Addendum 151 – UN Regulation No. 152

Revision 1 - Amendment 3

02 series of amendments – Date of entry into force: 30 September 2021

Uniform provisions concerning the approval of motor vehicles with regard to the Advanced Emergency Braking System (AEBS) for M₁ and N₁ vehicles

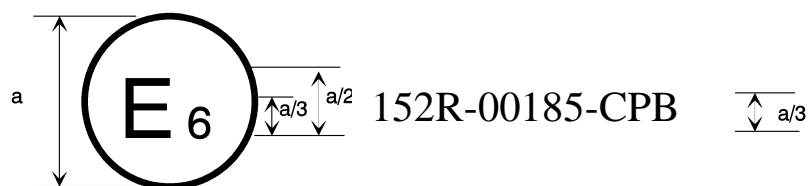
Annex 2, amend to read (addition of a letter "B" in the marking and its reference in the text):

The above approval mark affixed to a vehicle shows that the vehicle type concerned has been approved in Belgium (E 6) with regard to the Advanced Emergency Braking Systems (AEBS) pursuant to UN Regulation No. 152 (marked with C for Car to Car. P for Car to Pedestrian. B for Car to Bicycle). The first two digits of the approval number indicate that the approval was granted in accordance with the requirements of UN Regulation No. 152 in its original form."
